**AMENDMENTS TO THE DRAWINGS**

## **REMARKS**

### **II. Objection to the Drawings**

Fig. 2A

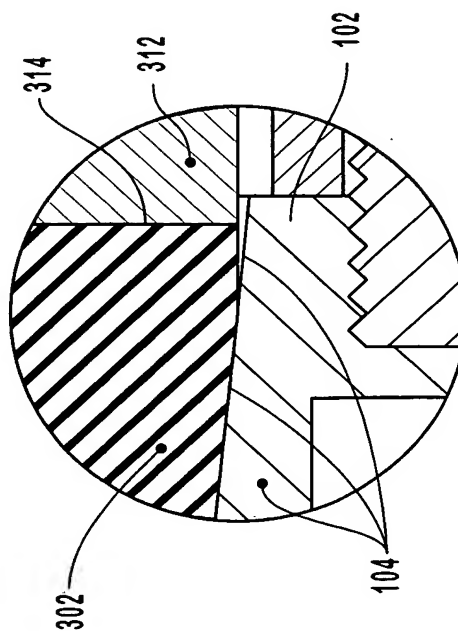
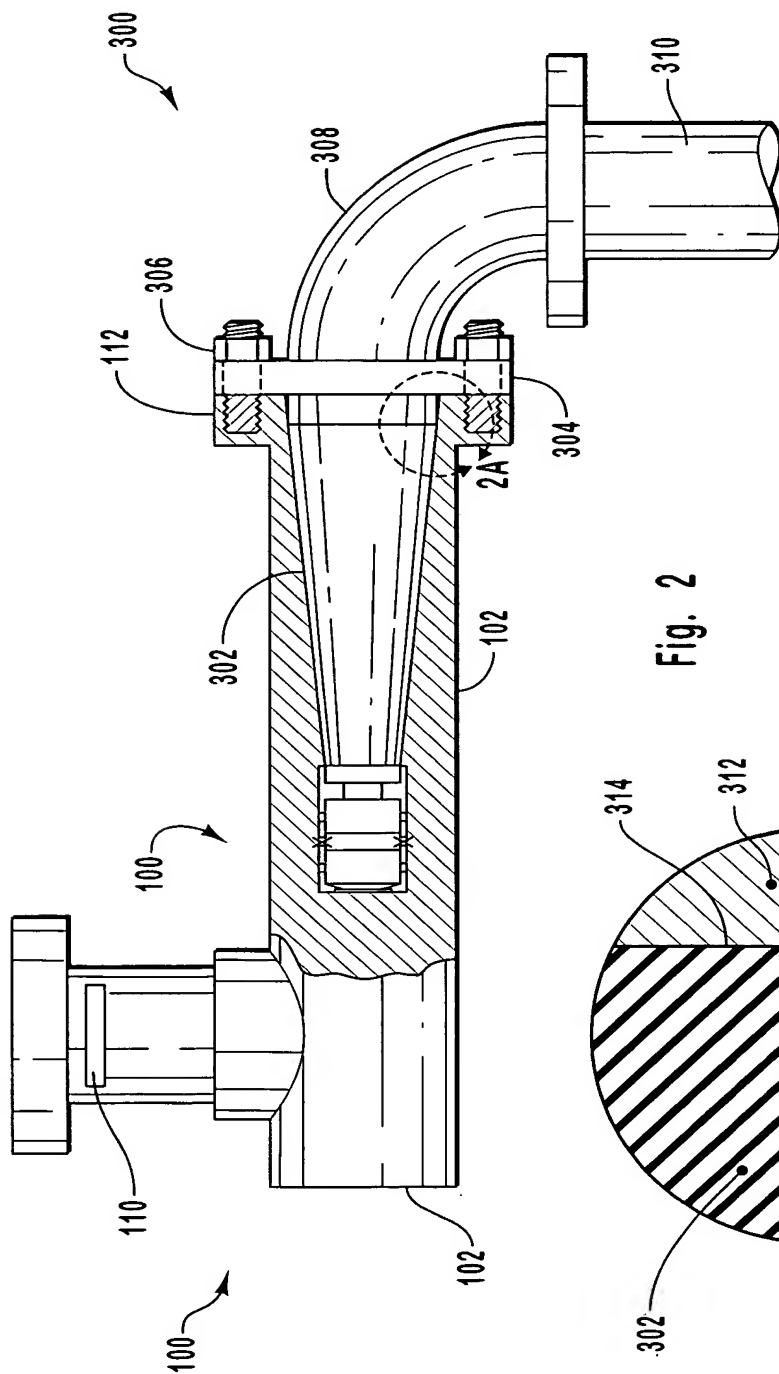
b. With respect to Figure 2, the Examiner has stated "The contact 108 is not shown in contact with electrical contacts 204C. It shows contacting the insulator 204D." In view of the replacement drawings submitted herewith, the objection has been overcome and should be withdrawn.

c. In connection with Figures 2A and 3A, the Examiner has stated "There are two elements in rightmost portion shown with different hatching. It is not clear if both of these are parts of the elbow fitting." Applicant disagrees and submits that the relation of the

aforementioned can be readily determined with reference to the specification. For example, the specification plainly refers to "... an interface portion 312 of the 90 degree elbow fitting 308," and to "terminal element 302." *Paragraph 0037. Emphasis added.* The specification further refers to "... a joint 314 ... cooperatively defined by the fitting 308 ... and the terminal element 302." *Id. Emphasis added.* Contrary to the assertion of the Examiner then, it is quite clear from the specification that "interface portion 312" is part of the "fitting 308," while the "terminal element 302" is not. Accordingly, no modifications are required to Figures 2A and 3A in this regard.

Fig. 3A

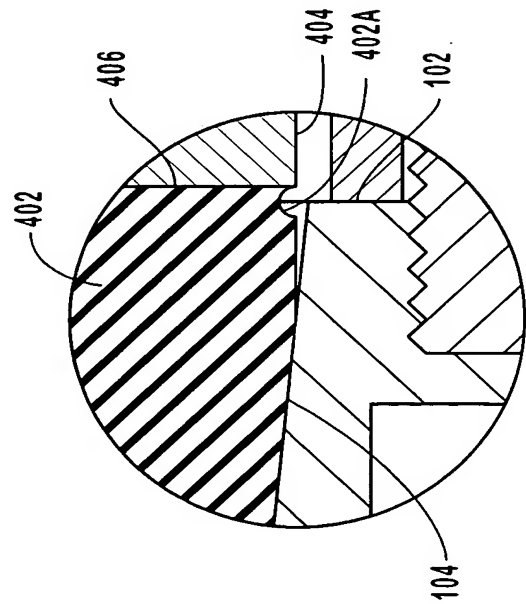
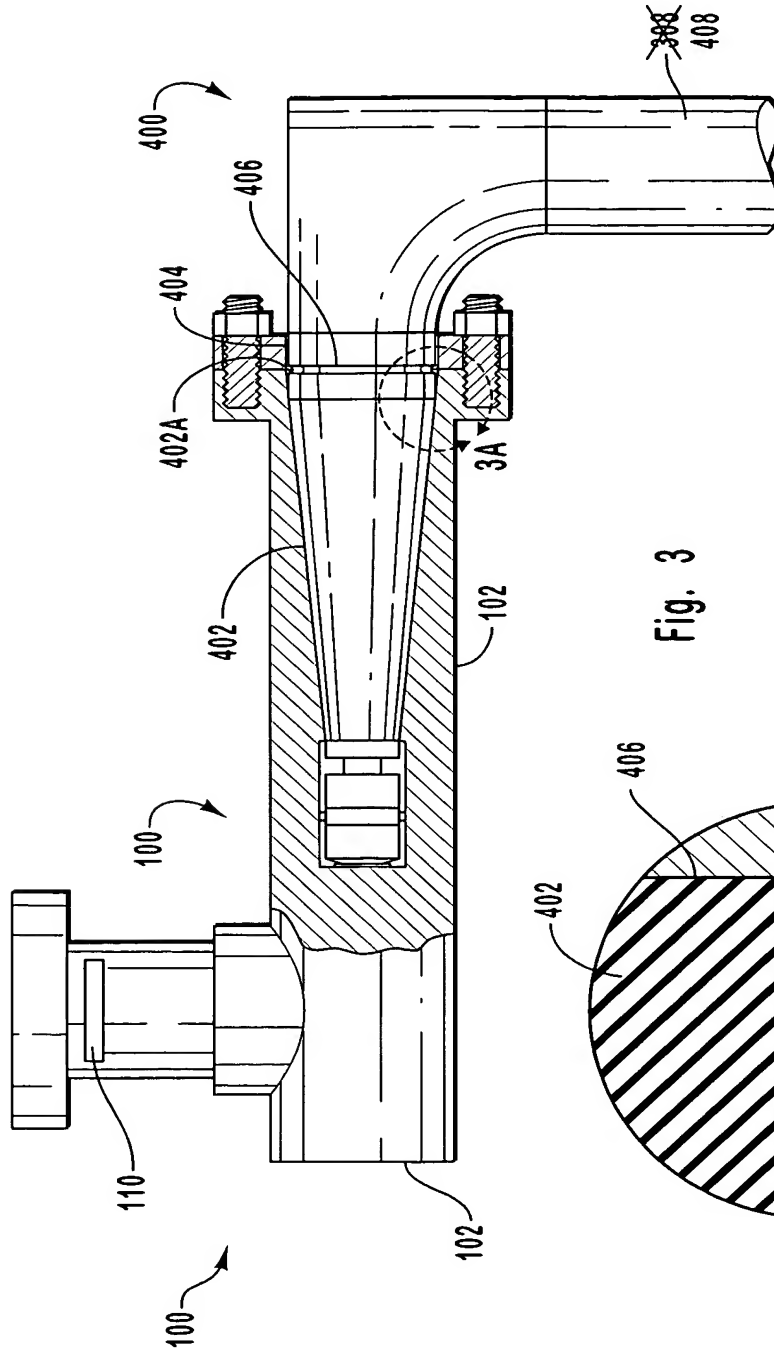
d. With regard to Figure 3, the Examiner has stated that "... '308' should be changed to '408'..." In view of the replacement drawings submitted herewith, the objection has been overcome and should be withdrawn.
